Subject: Response of FCC certification for the artecsound.

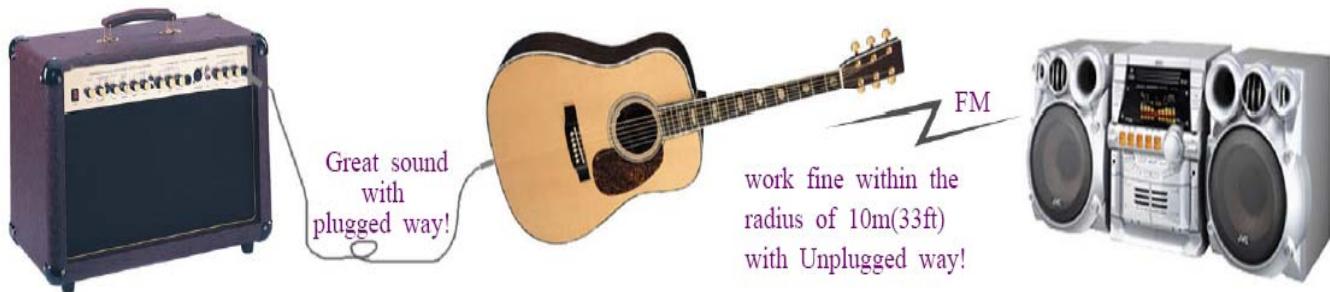
There is Input and Output jack. What will be connected to the input jack and to the output jack? Where will the transmitter be installed?

☞ Please refer to the Operational description & Test report.

"It can operate when the piezo transducer is connected to the input jack of the unit."

☞ Basic output jack's circuit is same with below part.

Output jack about FM transmitter action does not exert any effect.
